DEVELOPMENT REVIEW BOARD--SPEED MEMO

DRB CASE NO/PROJECT NO: 1004650

Sketch Plat/Plan

RE: Ceja Vista, Unit 3/sketch

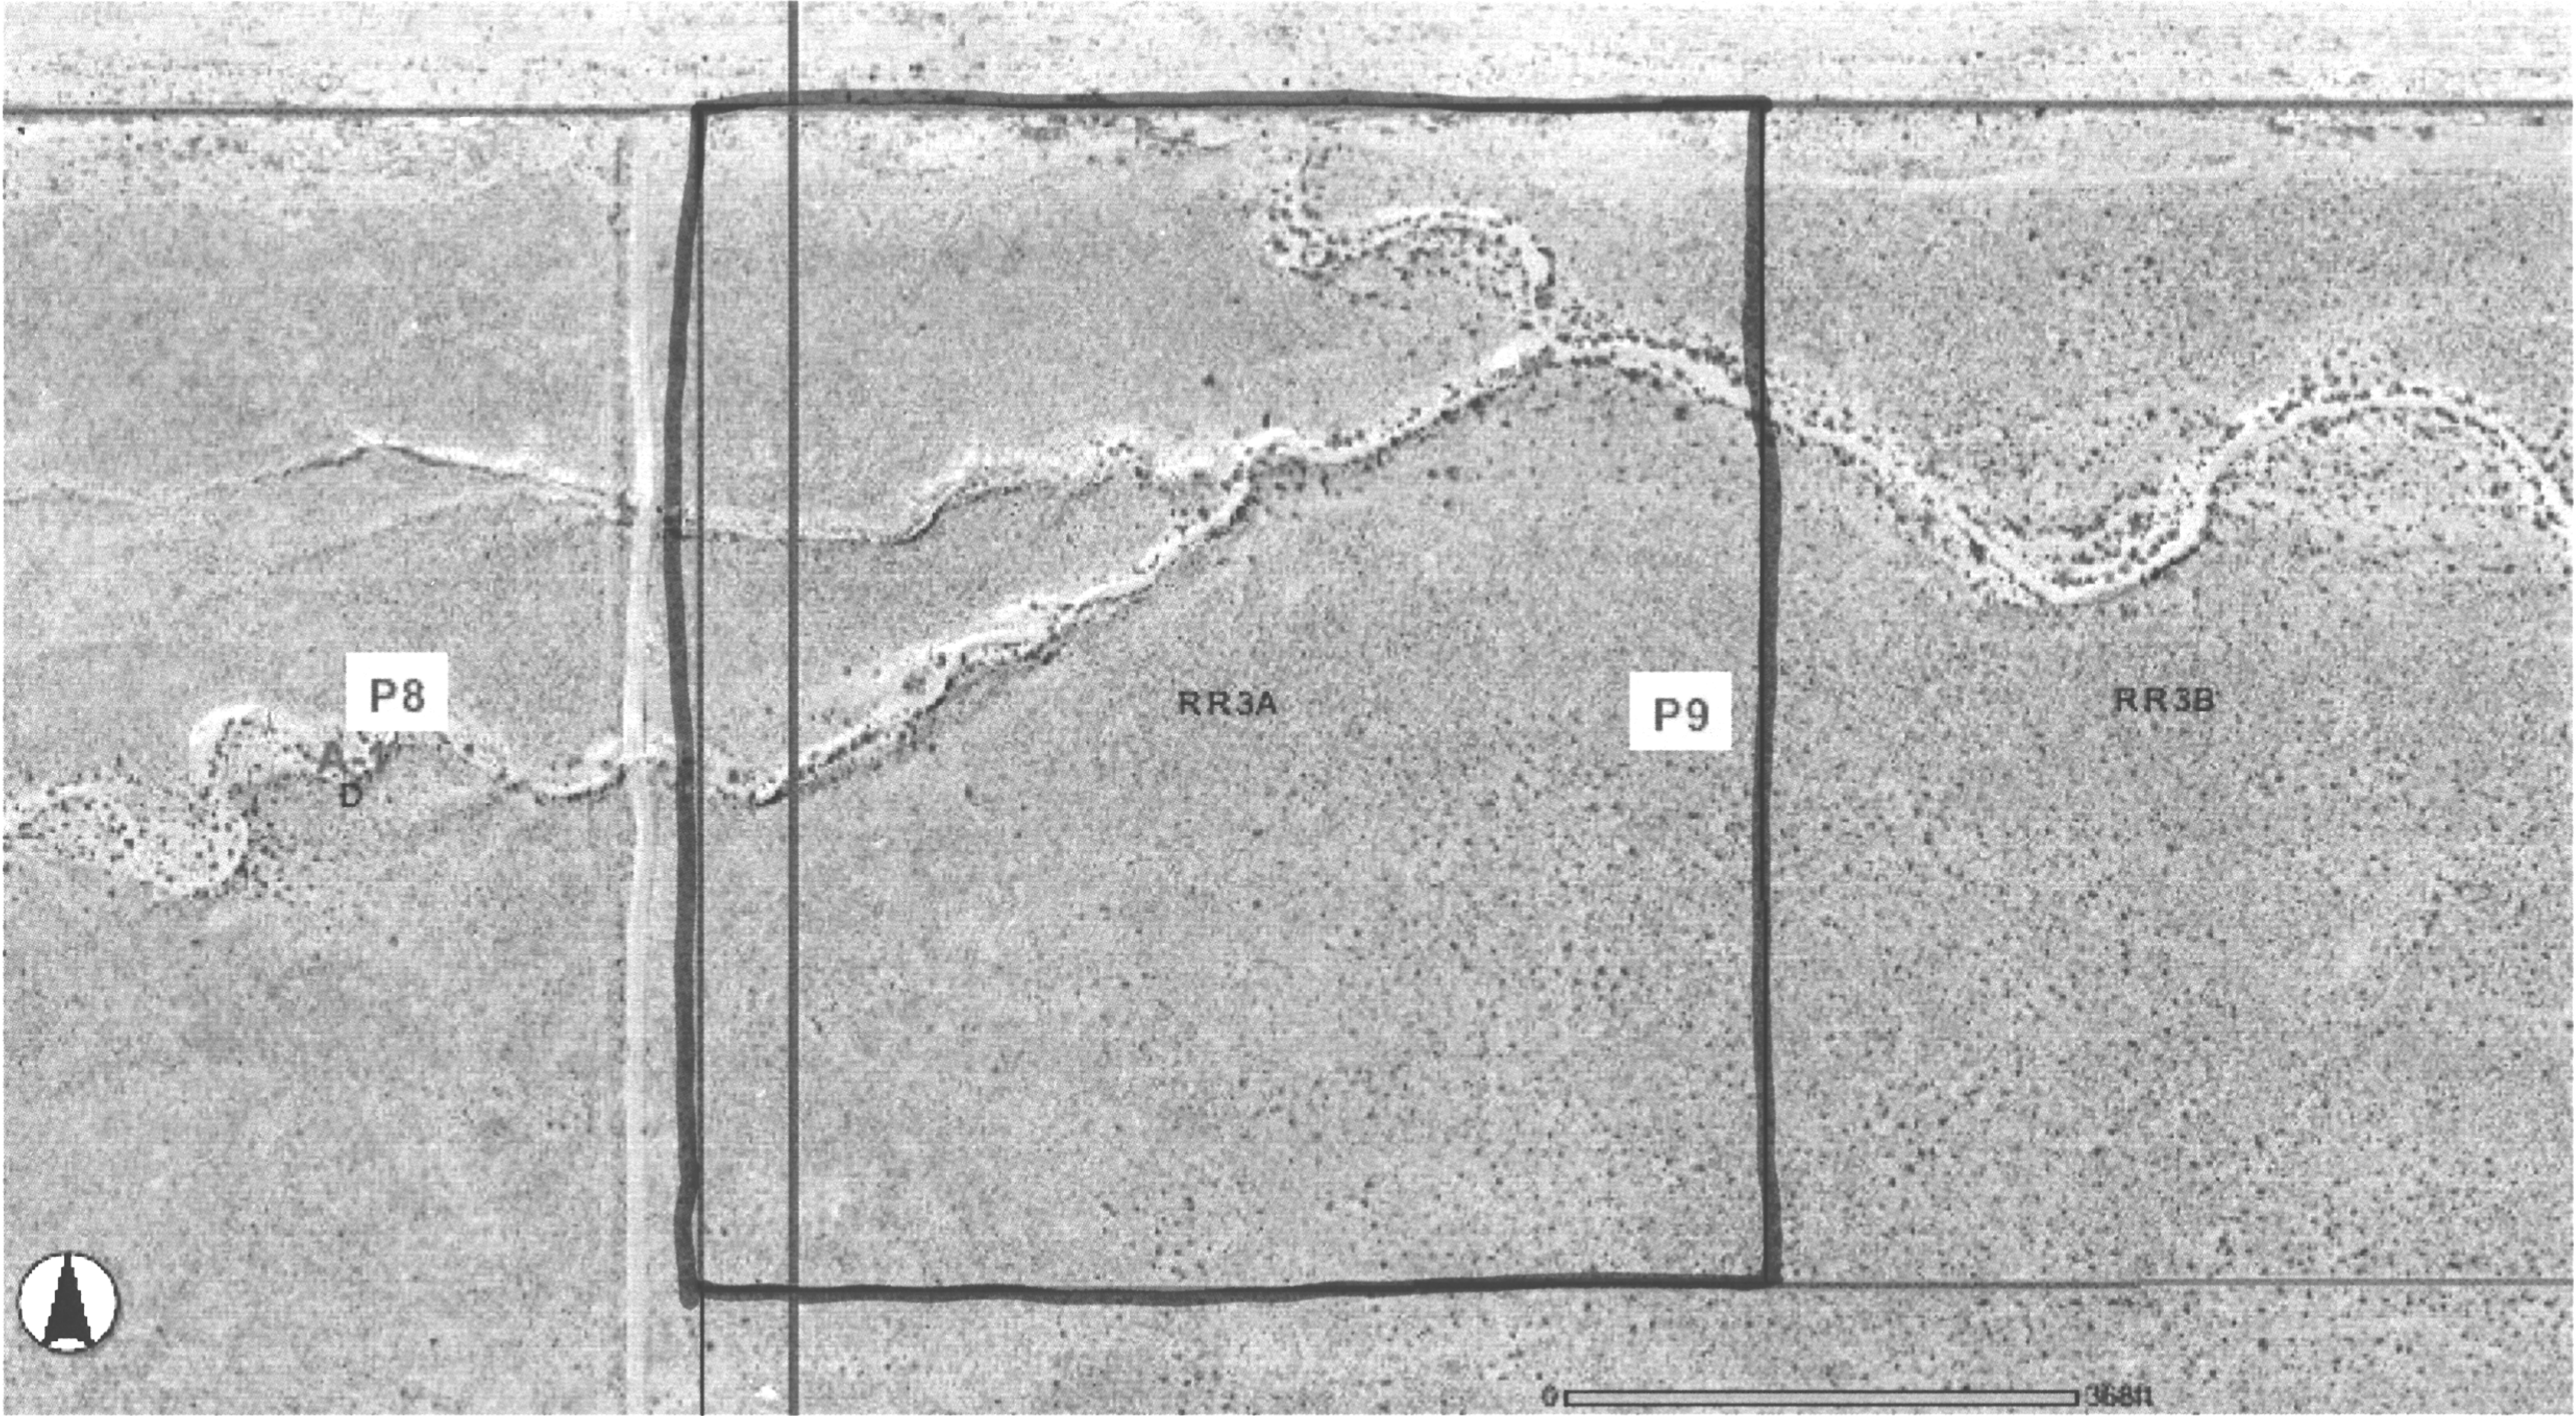
2. There is both insufficient vehicular and pedestrian access to Dennis Chavez Boulevard from the platted areas. Units 2 and 3 west of Unser line Dennis Chavez with about ½ mile of continuous rear yards. I see no breaks for pedestrians or vehicles. That would funnel vehicles from all of these units indirectly to Unser and then up to Dennis Chavez. This endless wall cuts off any possibility for pedestrian connections to future commercial services, parks and schools or bus service and once again creates a barren isolated space on the roadway. Dennis Chavez will be where the high school is located. The street and subdivision next to it should be designed so that kids can walk safely to the bus or school.

4. The park is poorly placed. It is too far to the west. It should be more centrally located. It would be difficult to walk there from most of the residential lots because of the circuitous street pattern and overly long street lengths.

Too many residential lots back up to the park. They should face the park to provide direct access and surveillance. The park should be treated like a public amenity rather than an afterthought.

If the park were to remain in the same spot, then lot 44 of unit 2 and lot 41 of unit 3 should be removed or moved to provide direct park access from these two disconnected subdivisions.

5. All three units or sketch plats have poor interior and interconnecting pedestrian and vehicular access.

6. The interior east/west residential street lengths in unit 2 are way too long. They need a north/south street cutting them in half.
